IREDELL COUNTY HEALTH DEPARTMENT

IMPROVEMENT PERMIT / AUTHORIZATION TO CONSTRUCT / OPERATION PERMIT / EXISTING SYSTEM INSPECTION

PERMIT# 138353 PIN# 4676238811

SUBDIVISION Quail Run BLOCK / SECTION 3 LOT 9 LOT AREA 2.095 Acre SITE CLASS. PS DESIGN FLOW 480 gpd L.T.A.R. .3

AS BUILT SKETCH

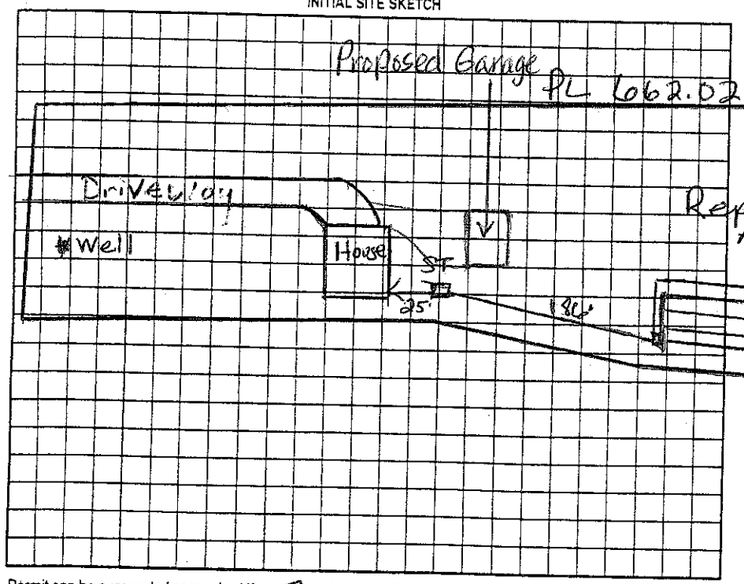
Comments/Conditions: Note: Stub out plumbing on high side of house to keep gravity flow to ST. Keep ST at least 25'+ from basement wall.

Comments/Conditions: Owner using "Grinder pump" for basement plumbing.

The proposed / existing Garage 26' x 32' addition does not appear to impact the existing septic system.

**NOTE: Shall be min. 5' from ST
